PROJECT OVERVIEW

COMPOSITE SITE PLAN | Site Plan

RESPONSE TO EARLY DESIGN GUIDANCE

FLOOR PLANS | Level 1

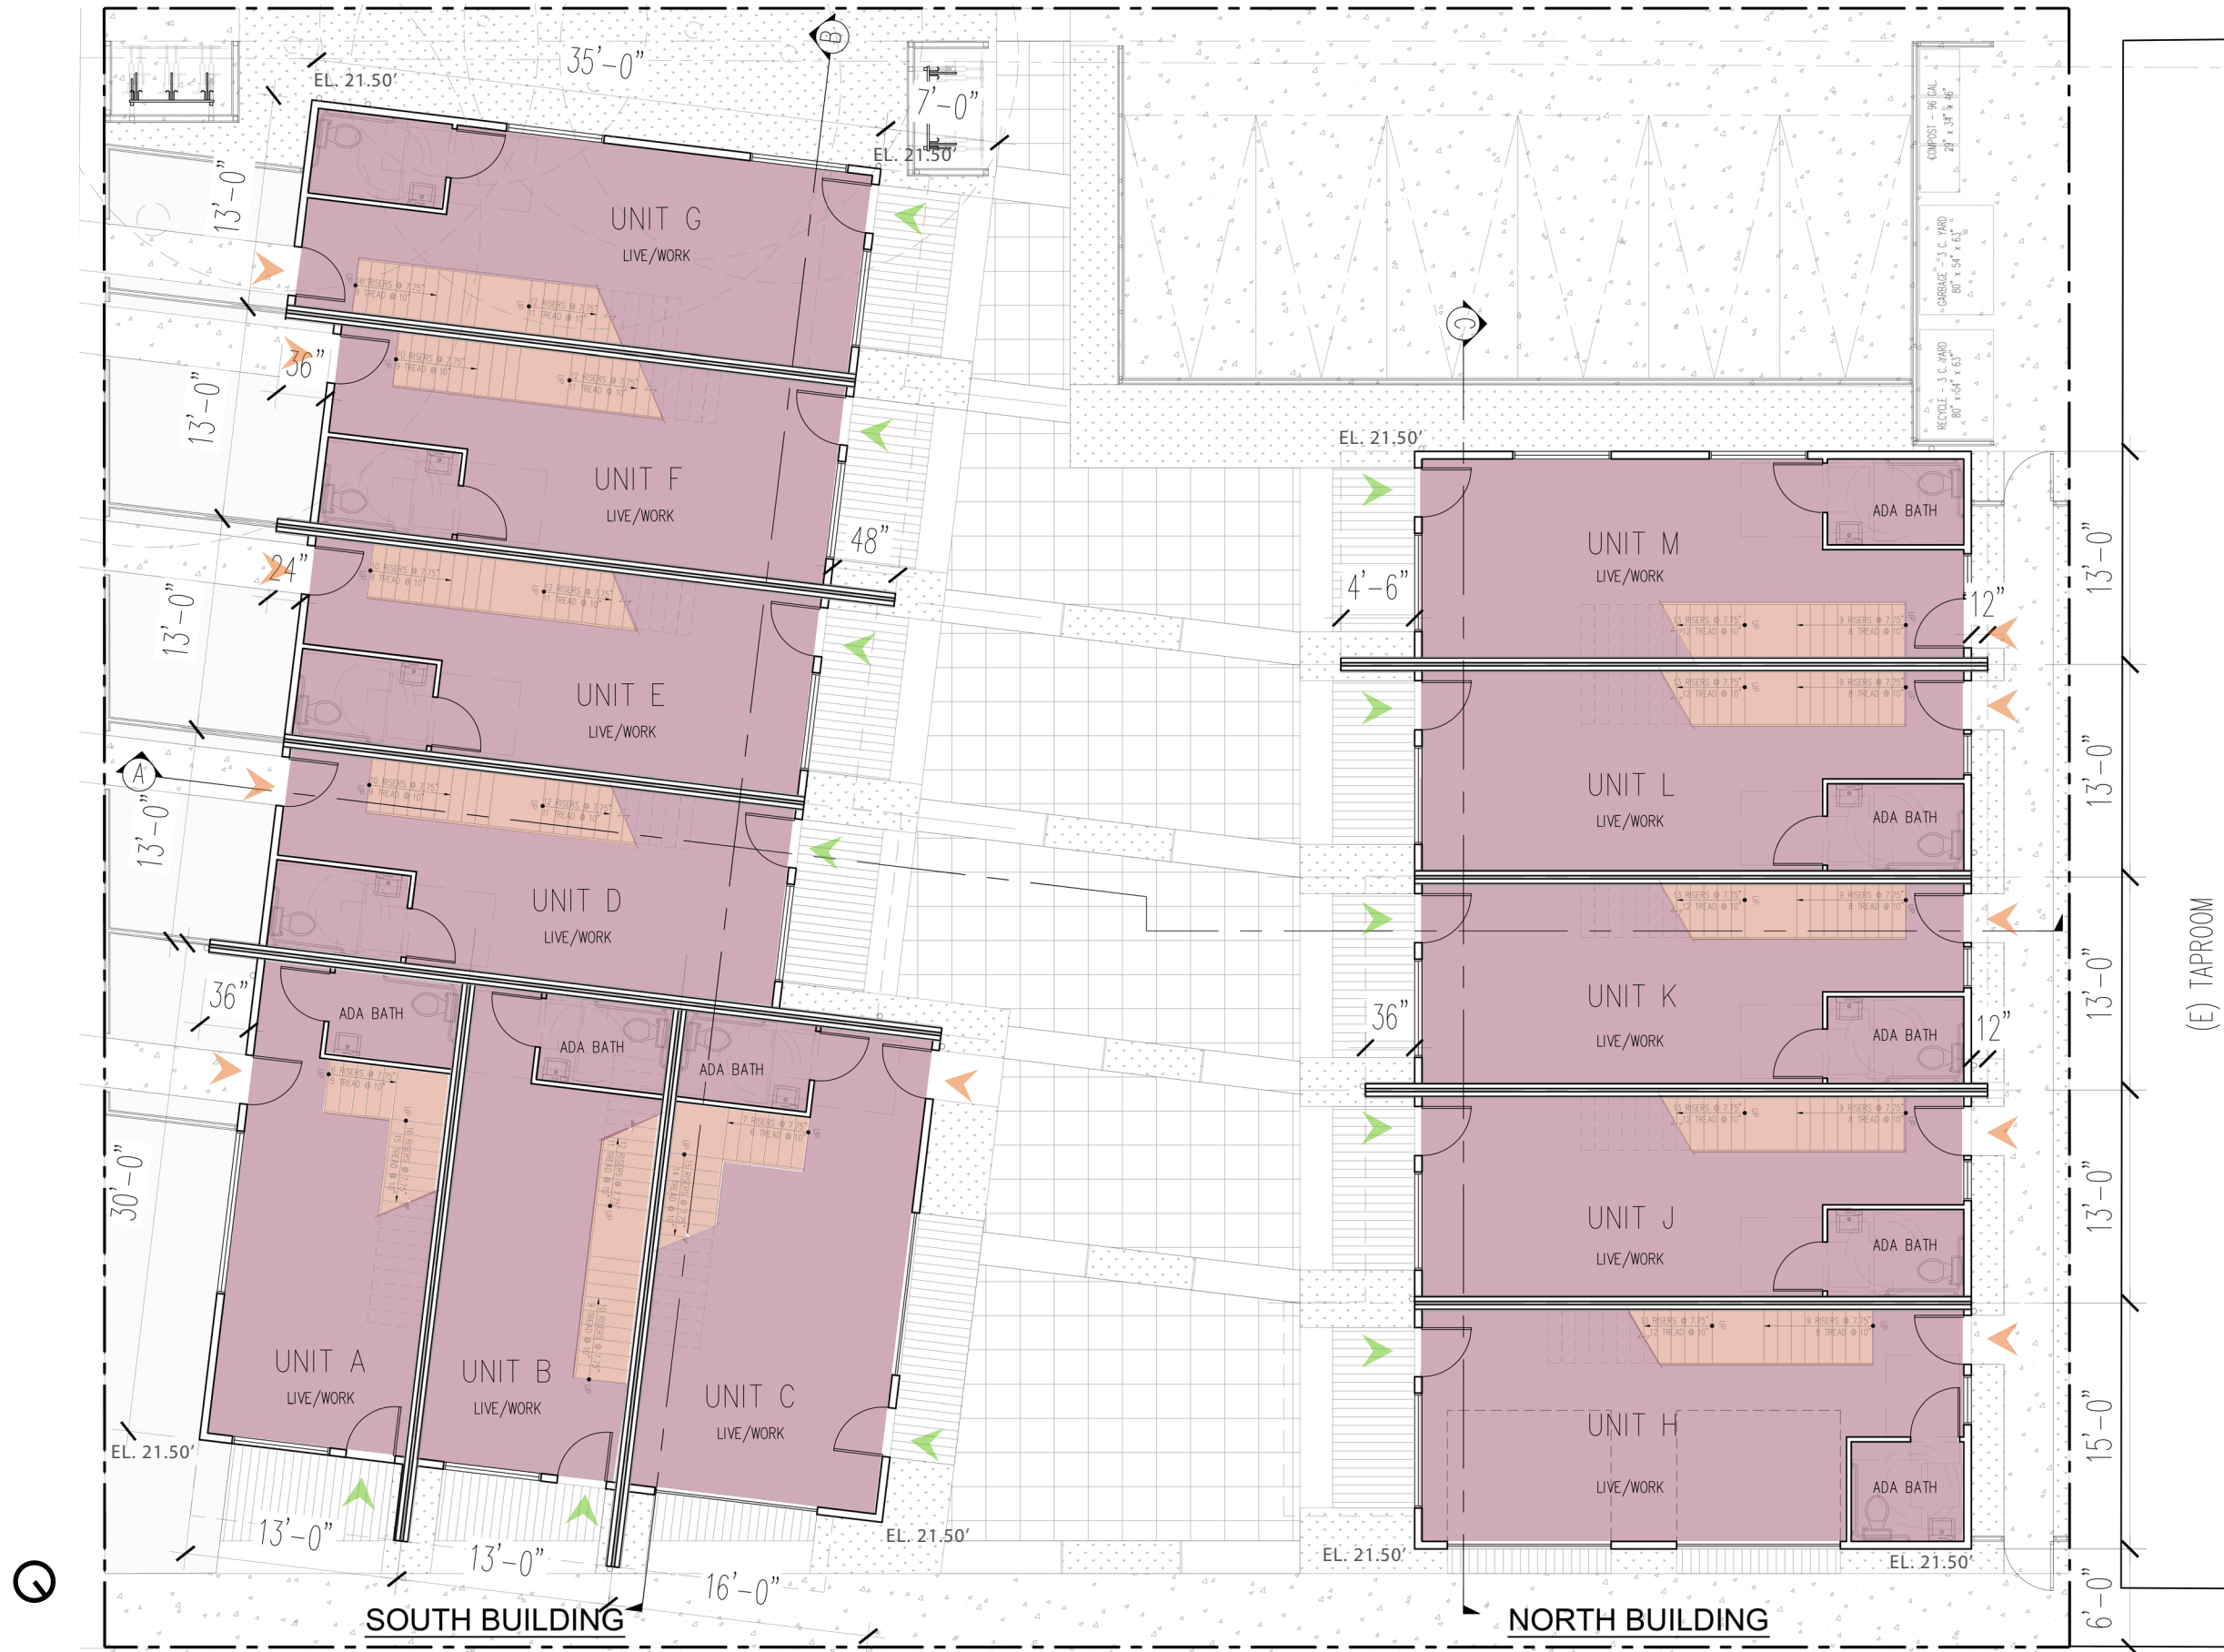
- c)** Staff is concerned with the lack of buffer/screening between the parking area and unit 12. Look for ways to provide added privacy between these two places. (DC1-C-2 Visual Impacts, DC3-C-2 Amenities and Features)

- i)** Ensure that trash storage is easily accessible from all residential units and sufficiently screened and distanced from the public amenity areas, pedestrian pathways, and unit entries to minimize visual impacts. (DC1-C-4 Service Uses, PL1-B-3 Pedestrian Amenities, PL2-A Accessibility)

Greater separation between parking and unit 12(M) is provided and has been revised to landscaping. The landscaping proposed in this area is larger/taller plantings. The windows in unit 12, at the main floor, are elevated to provide screening from vehicles and headlights, increase privacy and security and add wall space within the work portion of the unit.

Trash is in the NW corner of the site with at-grade access for all tenants. The trash enclosure is screened and is not visible from the public courtyard.

ELEVATIONS | South Building

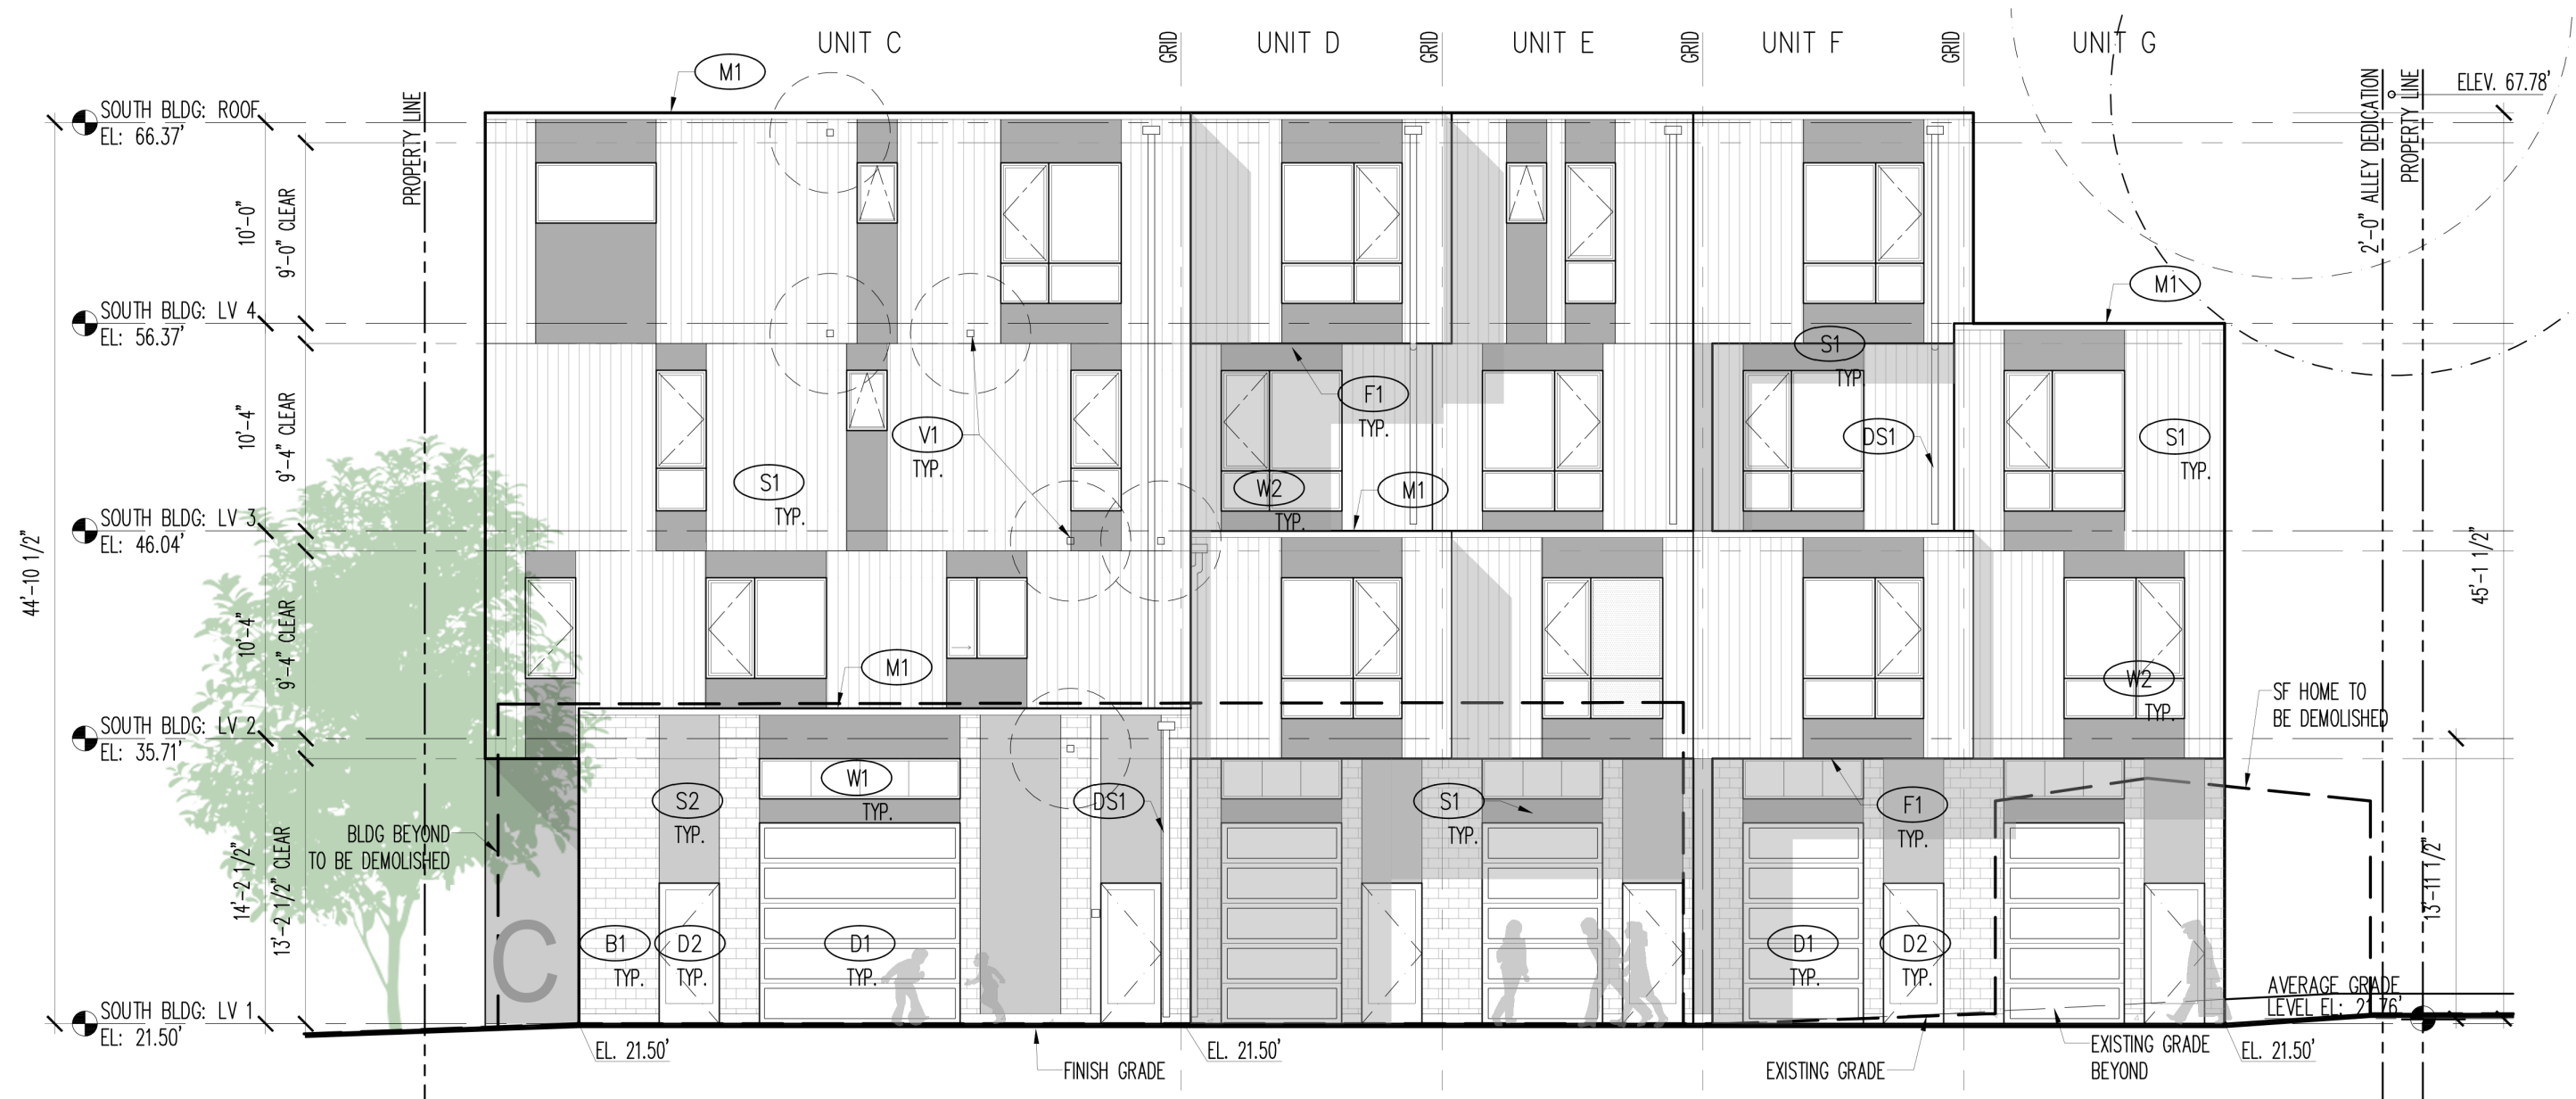
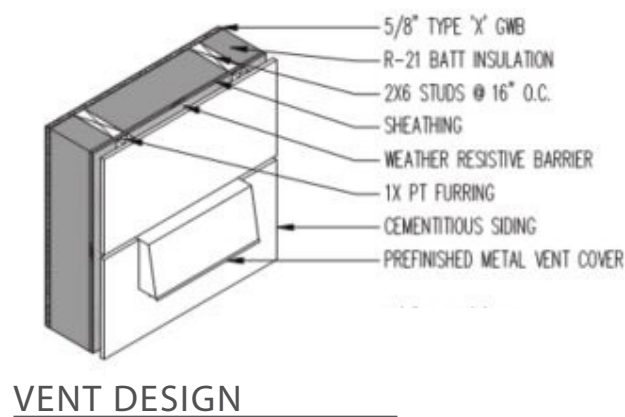
b) Due to the south building’s proximity to the overpass, Staff encourages the exploration of exterior-facing materials and color palettes that can obscure/deal with higher levels of dust/pollution over time. (DC4-A Exterior Elements and Finishes)

RESPONSE:
The south facing façade intends to employ the same materials as all other facades. Masonry is proposed at grade and wood siding at upper floors. The upper floors wood siding is relatively dark and textured which will obscure any potential dust/grime over time.

EXTERIOR LIGHTING PLAN | Site Plan

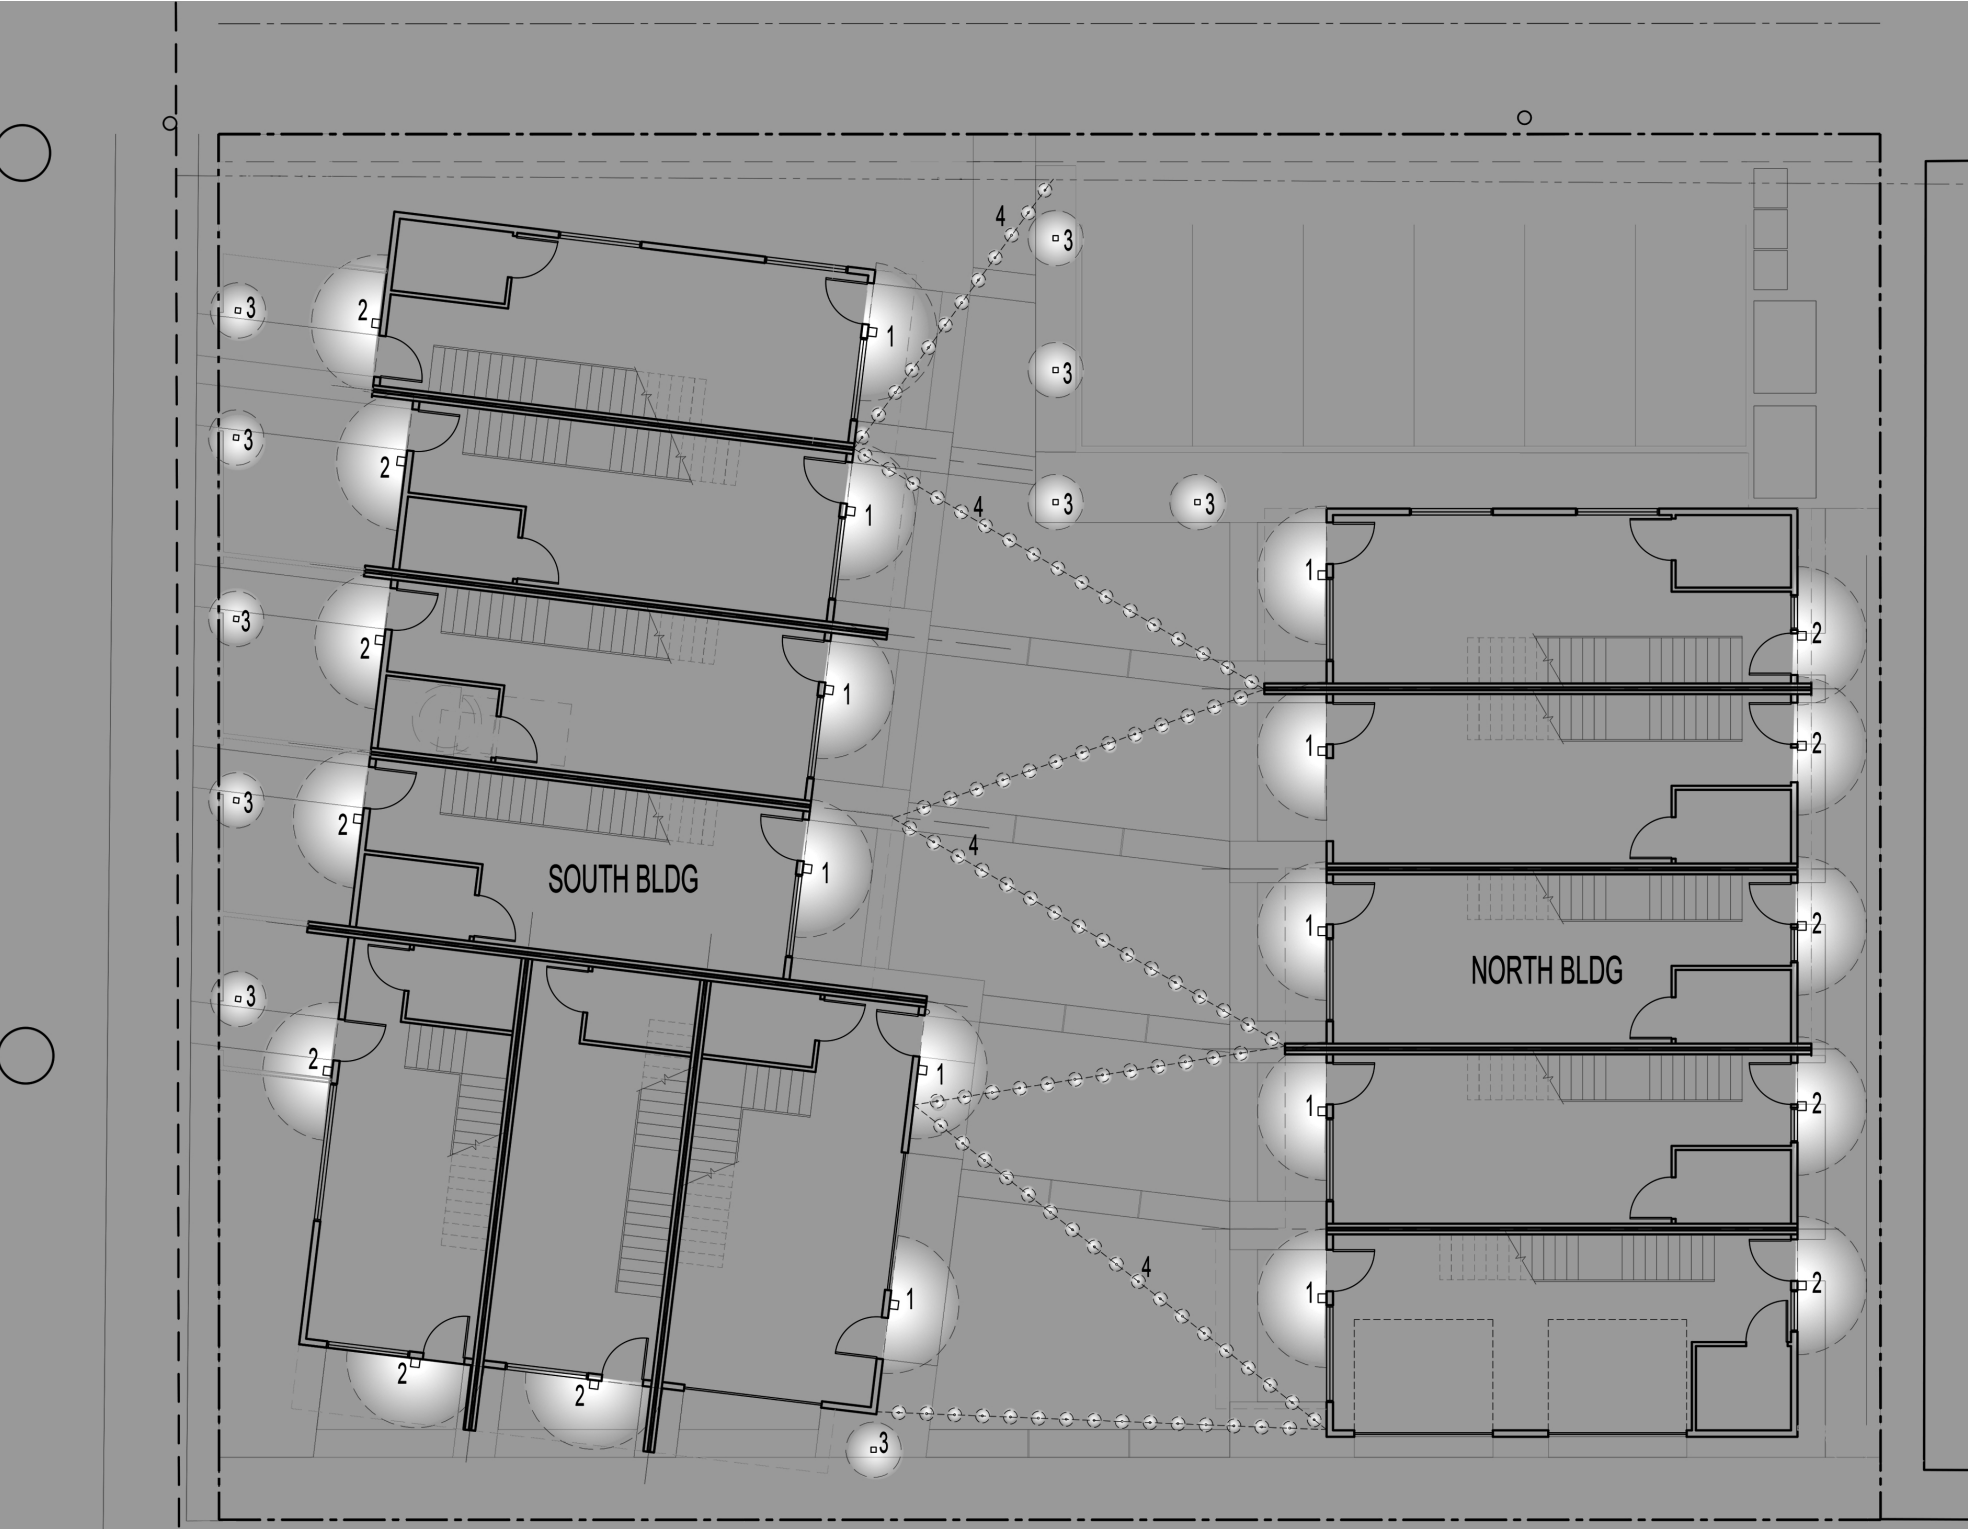
- e)** Develop a robust landscaping and lighting plan that cohesively utilize softscaping, hardscaping, and lighting techniques for an intimate and attractive courtyard area. The lighting scheme should sufficiently illuminate the pathways, entries, courtyard, and other architectural/landscape features for a safer and more attractive space. (DC3-C-2 Amenities and Features, DC4-D Trees, Landscape, and Hardscape Materials, PL2-B-2 Lighting for Safety)

Landscaping, paver pattern and differentiation and lighting techniques are use in unison to accentuate the courtyard. Landscaping is used within the courtyard, but sparingly and intentionally low to differentiate/accentuate unit individuality while maintaining visibility. Courtyard perimeter landscaping, specifically at the west side is used to screen parking, trash enclosure and to further enclose the courtyard.
